Docket 71-9251
Model BW-2901

Subject: Additional information for the for the model BW-2901 Shipping Package Certificate of Compliance No. 9251

Reference: (1) NRC Request for Additional Information "CERTIFICATE OF COMPLIANCE NO. 9251 FOR THE MODEL NO. BW-2901 PACKAGE" Dated February 3, 2003.

Response to NRC Request For Additional Information
Docket 71-9251
Model BW-2901 Package

Figure 6-4
Original Pellet Tray Model

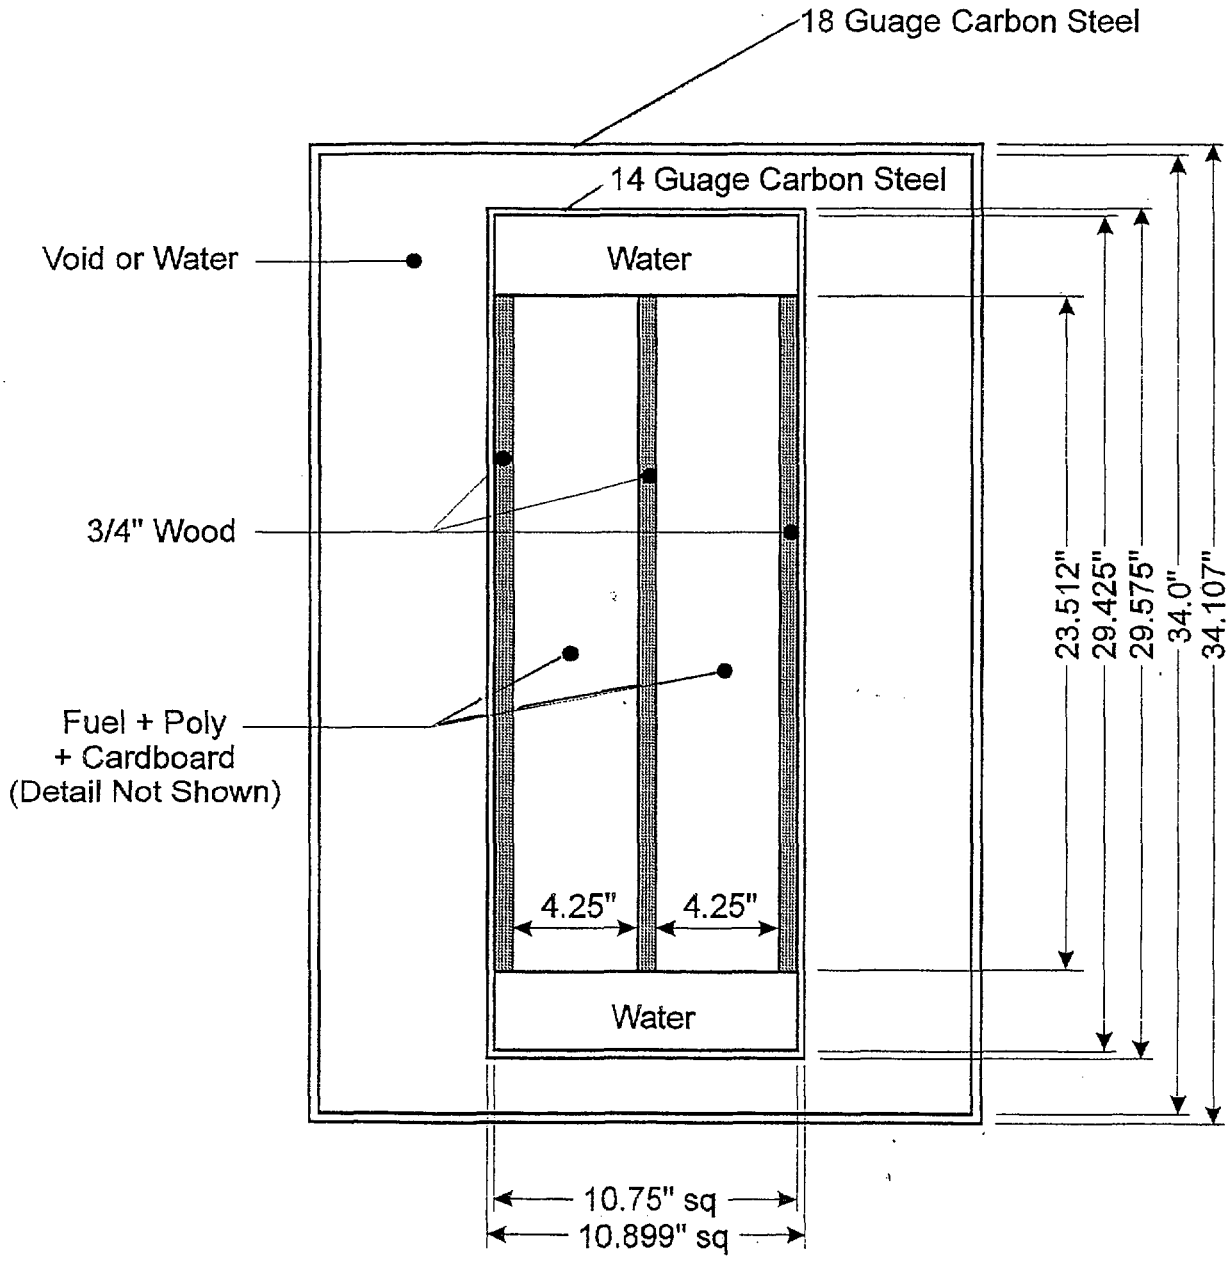
Request: Submit improved quality copies of the following figures from Chapter 6: Figures 6-4, 6-5, and 6-6 (which should be in color). The figures were not legible.

Response: Chapter 6, Figures 6-4, 6-5, and 6-6 have been revised for clarity.
